ADDENDUM NO.1

Board of Darke County Commissioners Courthouse Security Entrance Addition

May 21, 2019

BASEMENT FLOOR PLAN

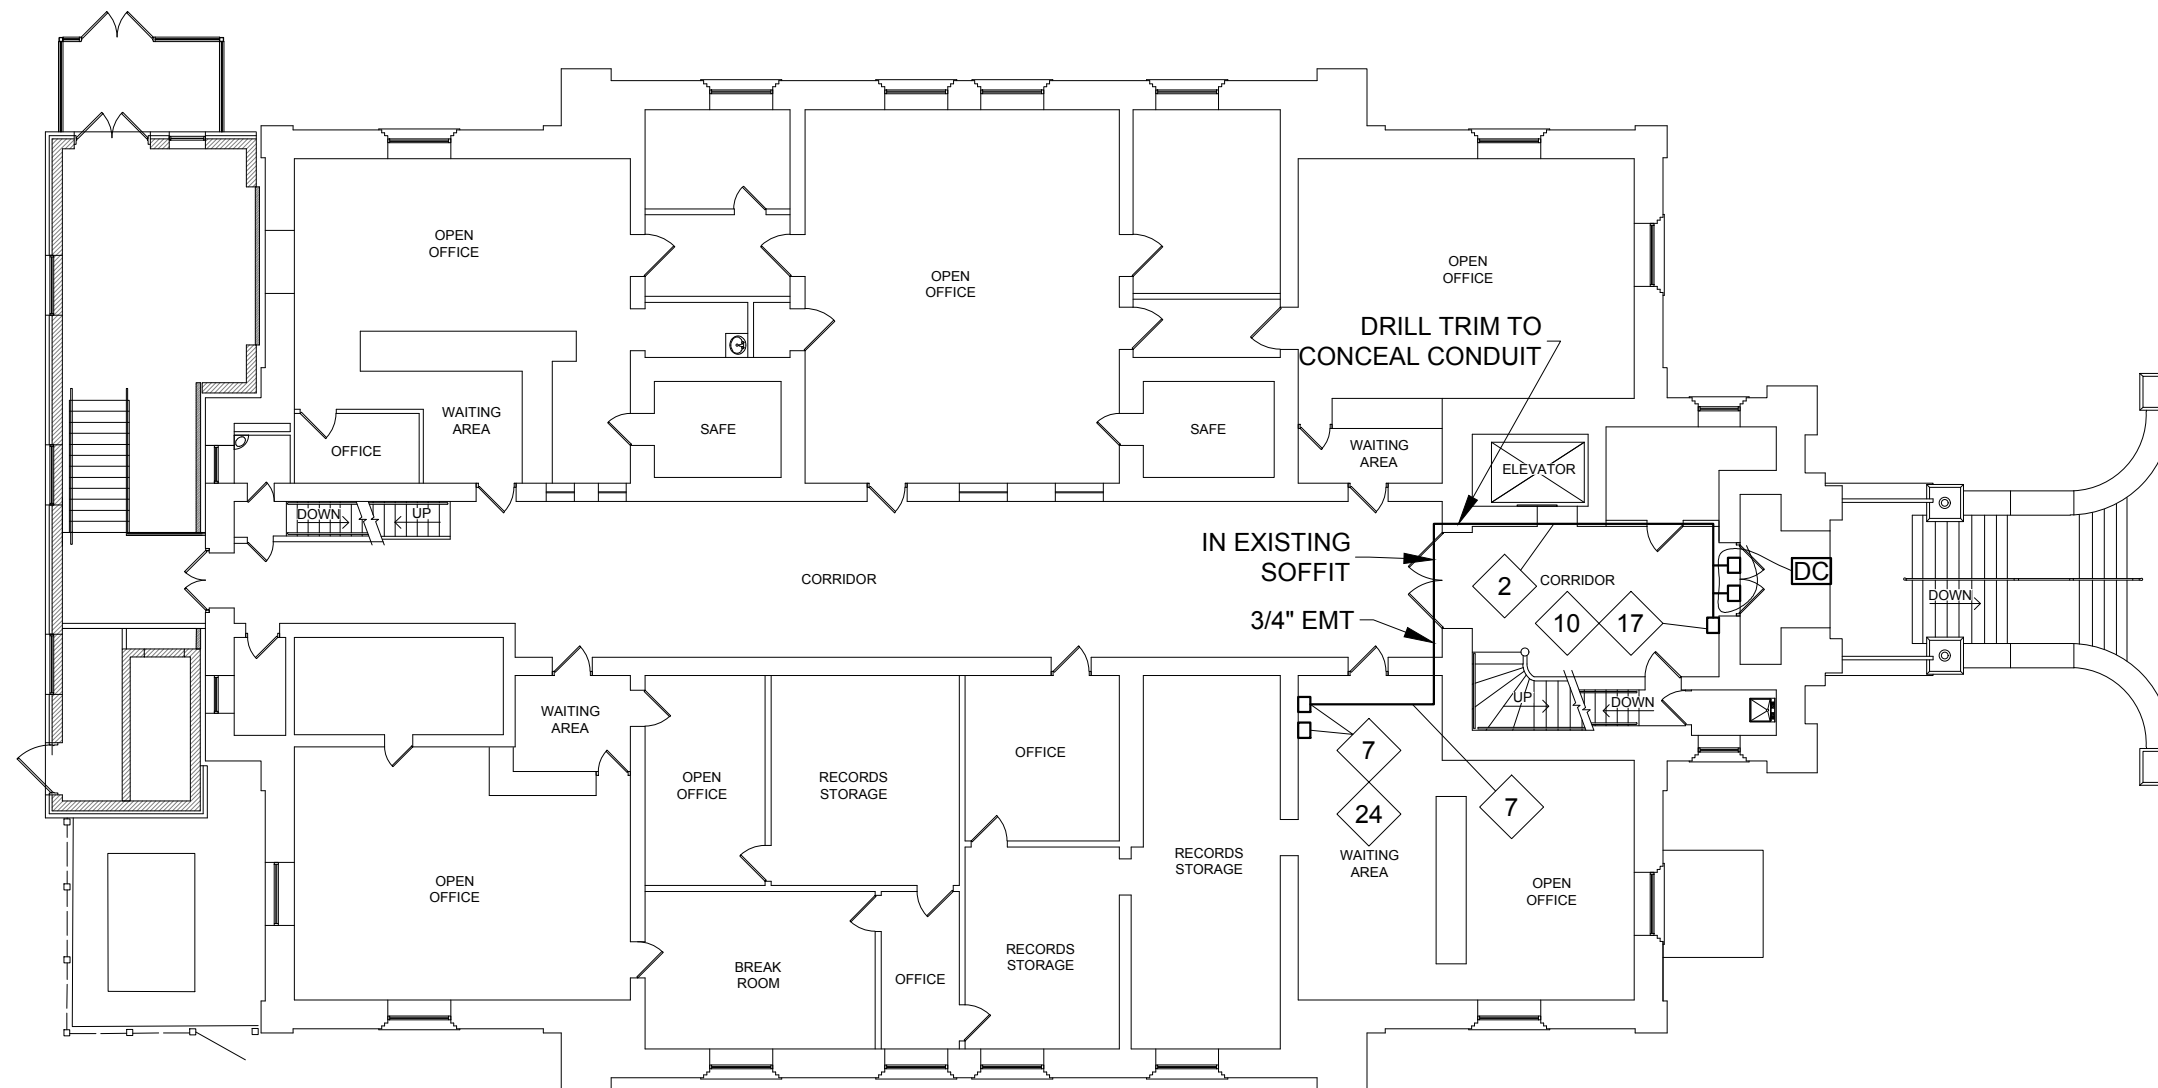
- a. On the Basement and First Floor, change the raceway pathways through the existing building to be as shown on attached sketches SK-E2-01-A and SK-E2-01-B.
- b. In Electrical Systems Plan Keynote 2, change “500” to “700”.
